SERVICE BULLETIN

Ref: SRV-019-002

Product: 200 Series and SDX AirFlex Headers

Re: Belt Tensioner Information

Figure 1

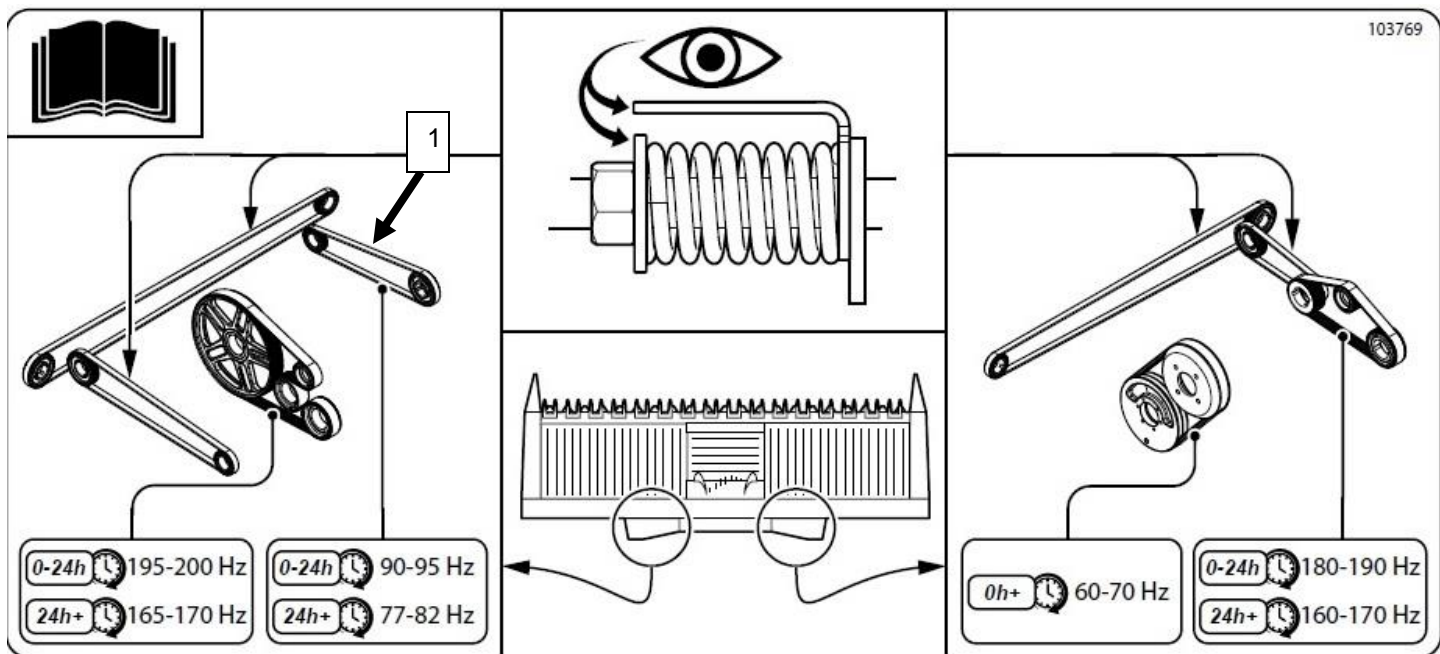
1. We have seen some failures of the drive belts on the AirFlex headers this past season due to improper tension. To help make certain that the belts are tensioned properly a new decal will be added to all headers. This decal shows the proper tension on the belts. (See Figure 1).

Figure 2

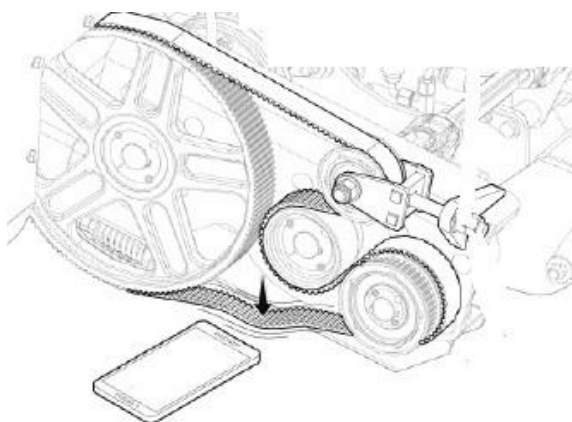
- Hold the phone under the long span of the belts with the Fine Tuner app turned on. (Figure 2)
- Tap the belt with a large wrench 3 or 4 times.
- Read the Hertz on the phone (example in Figure 3)
- Adjust the belt to the proper tension listed on the decal.

Figure 4

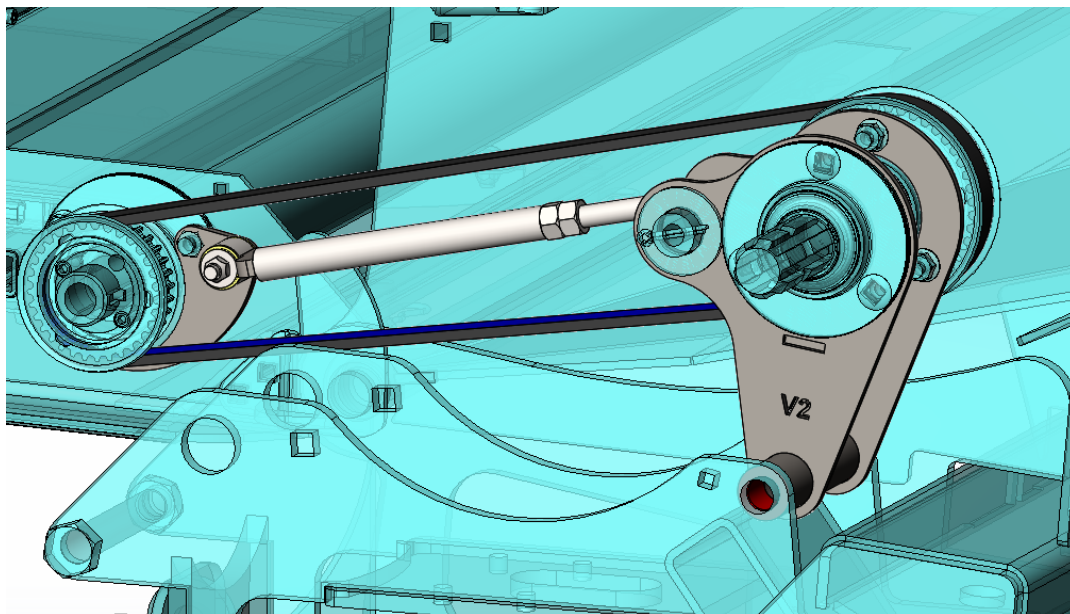
2. The Feeder Deck drive belt tension system was also changed for the Model Year 2019 headers. On past years the tension system was a spring system. This spring system would allow the belt to jump if the combine reverse was too harsh or if the system was “rocked back and forth”
 - To resolve this issue in 2019 the drive belt for the feeder deck (item 1 Figure 1) no longer has a spring on the tensions system.
 - This belt must be adjusted with the fine tuner app. (Figure 4)
 - For units Model year 2017 and 2018 that have an issue with the belt failure due to the combine there is a kit to convert the spring tension system to the direct tension system. The contents for the kit are listed in Figure 5.
 - **Note: This kit will only work on Model Year 2017 and 2018 Headers. This kit cannot be installed on any MY 17 that had the subframe converted to a non-suspend frame.**
